ADDENDUM TO THE CONTRACT DOCUMENTS

ADDENDUM NO. 02
	Project: Solano Community College District Early College High School Portables Project Project Number: 20-012
	Date: June 23, 2020

**EARLY COLLEGE
HIGH SCHOOL
PORTABLES**

**SOLANO COMMUNITY
COLLEGE**

ENLARGED SIGNAL PLAN
SCALE: 1/8" = 1'-0"

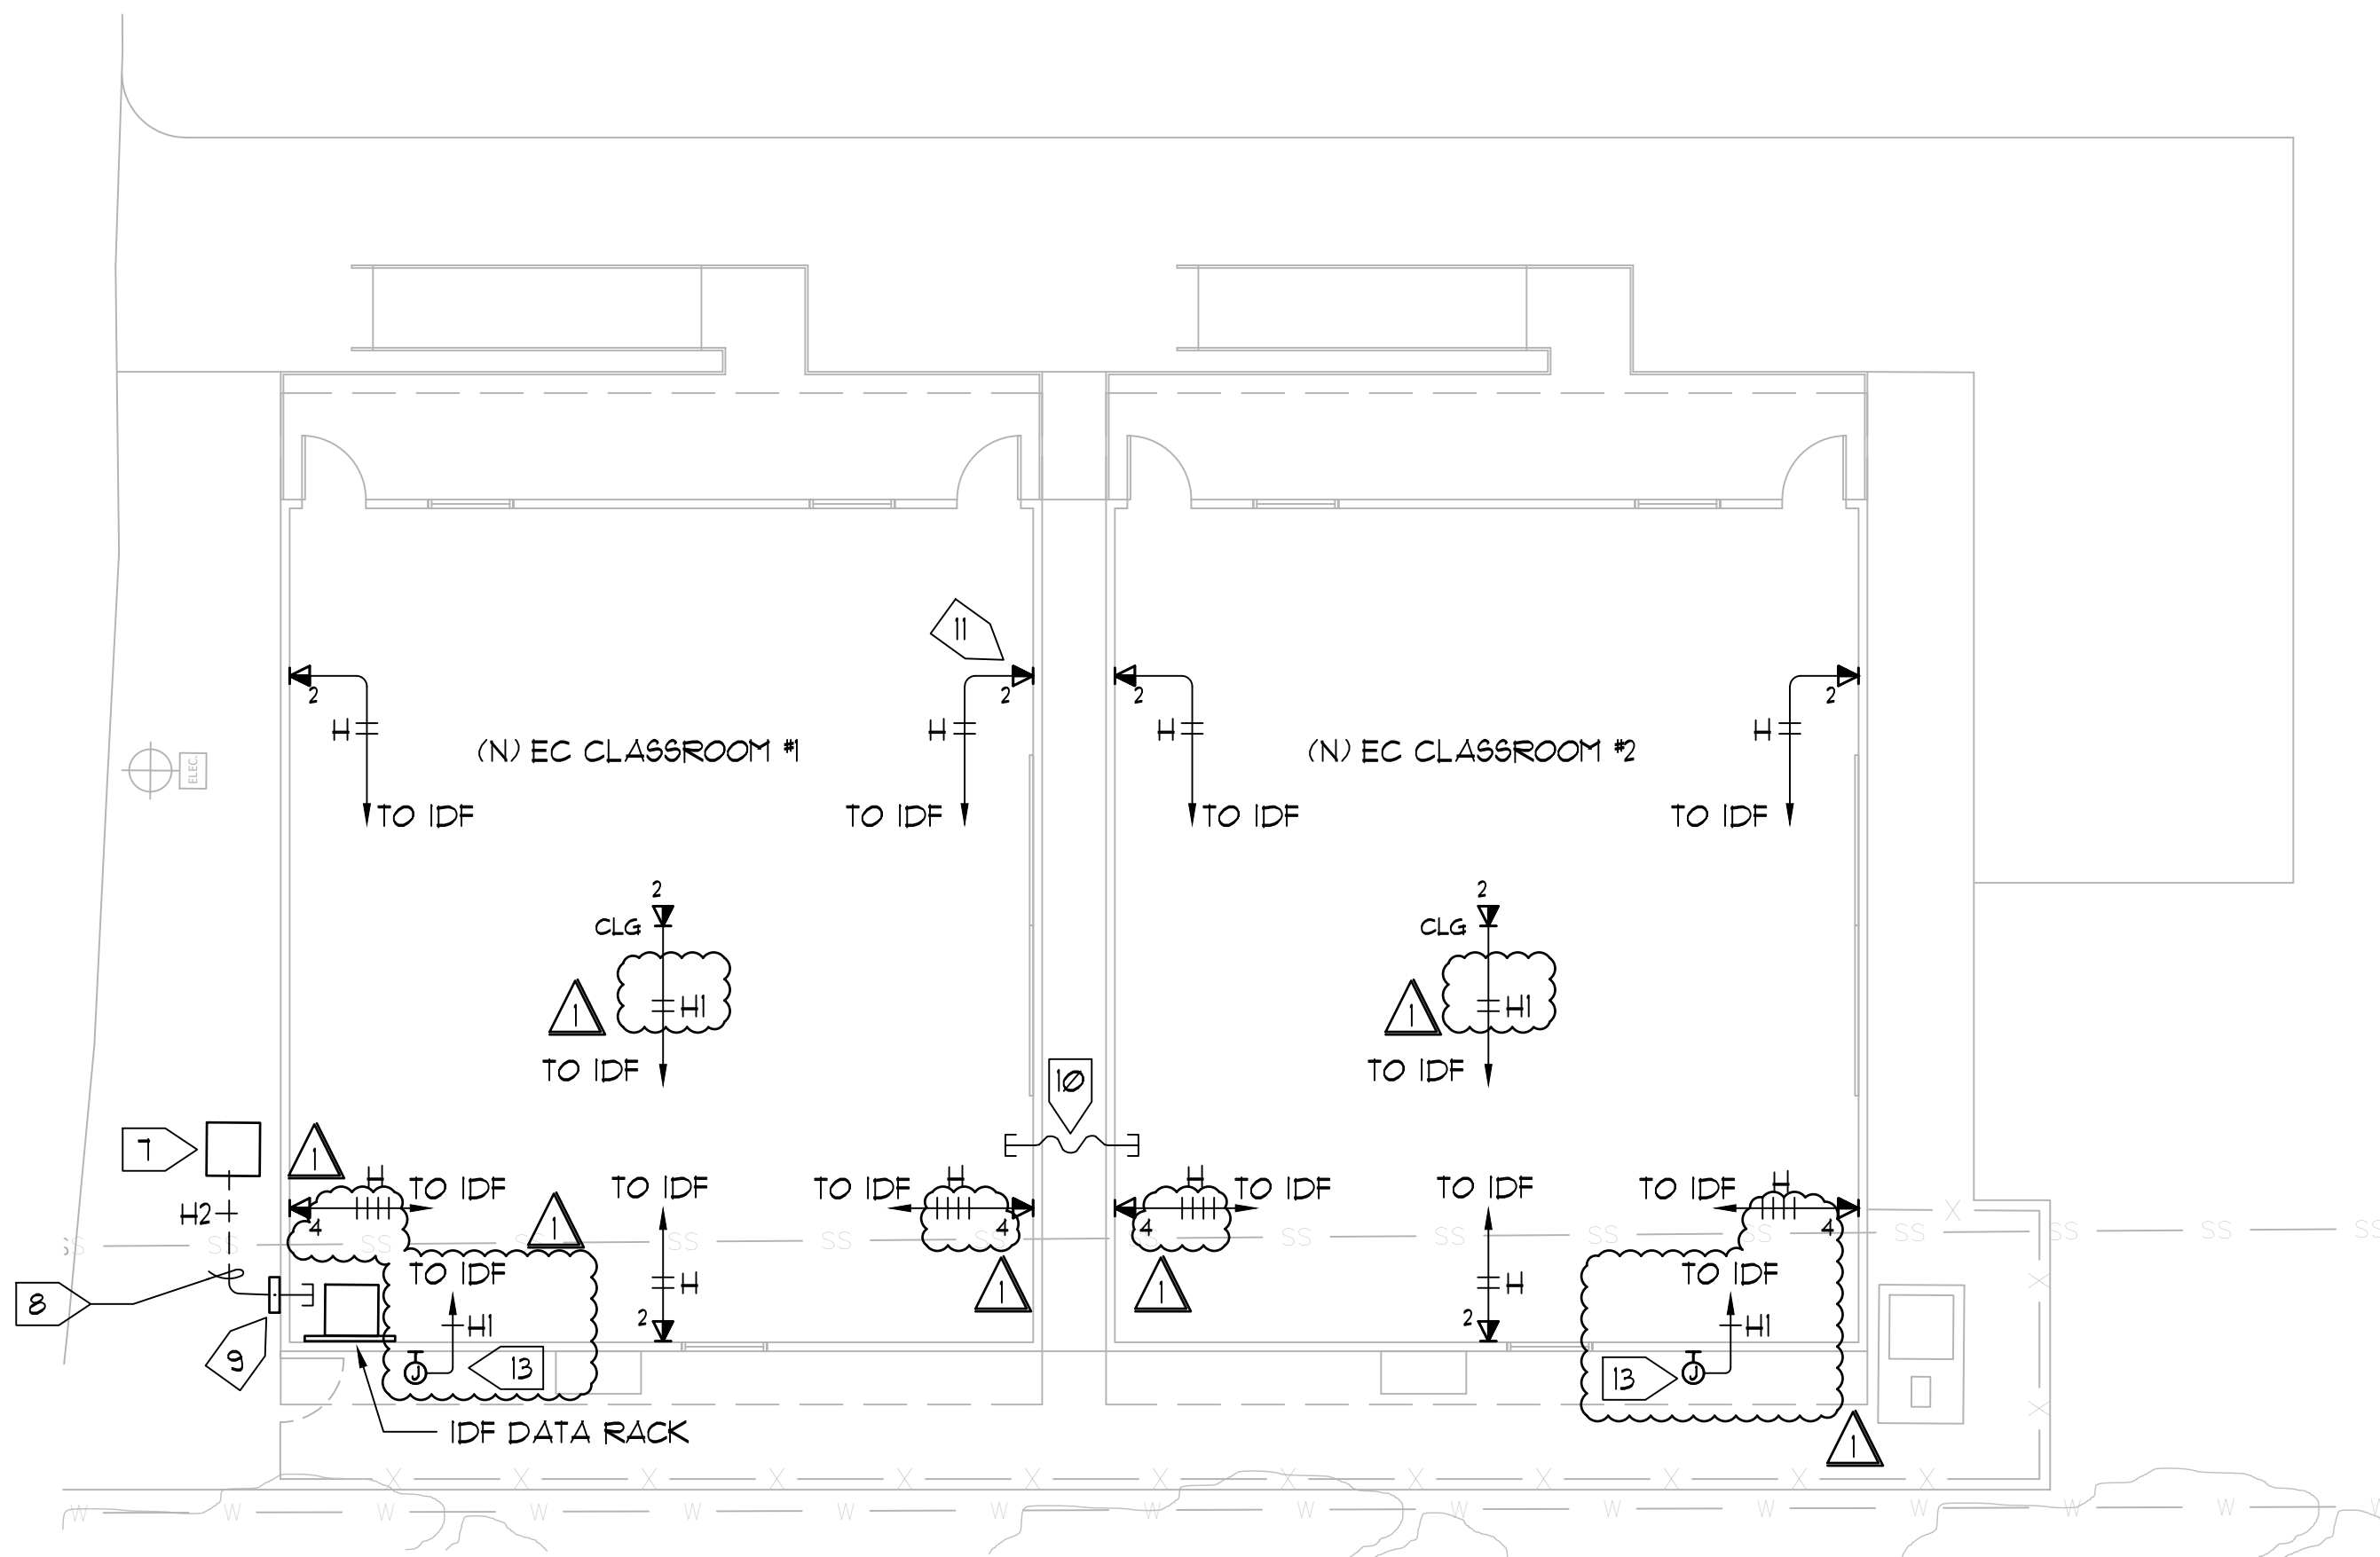
- 5** Revised Enlarged Power Plan A/E3.0. Added a ceiling receptacle for a projector in each Portable Classroom and added Numbered Note 12. Revised Numbered Note 4 informing contractor to install a 20 amp, 120 volt, 1 phase in electrical panel for projector. Revised Numbered Note 6 informing the contractor to provide new IDF cabinet, fan kit and install on plywood backboard per detail C/E1.1. Revised Enlarged Signal Plan B/E3.0. Revised ceiling data cabling to (2) CAT6A cables in lieu of (1) CAT6 and (1) CAT6A cable. Revised the number of data cables at the back of the classroom, on the East and West walls to (4) data cables in lieu of (2) data cables per

College District IT Department request. Added an exterior wireless access panel (WAP) enclosure and CAT6A data cable. Added Numbered Note 13 to address the exterior WAP enclosure. See sheet E3.0.

13. PROVIDE AN EXTERIOR WIRELESS ACCESS PANEL (WAP) ENCLOSURE WITH DATA CABLE FOR EXTERIOR WAP. TERMINATE DATA CABLE IN ENCLOSURE TO CONNECT TO WAP. COORDINATE EXACT EXTERIOR WAP ENCLOSURE WITH COLLEGE DISTRICT IT DEPARTMENT FOR A COMPLETE AND OPERATIONAL INSTALLATION. CAULK AROUND ENCLOSURE AND SEAL EXTERIOR WALL PENETRATION WEATHERPROOF.
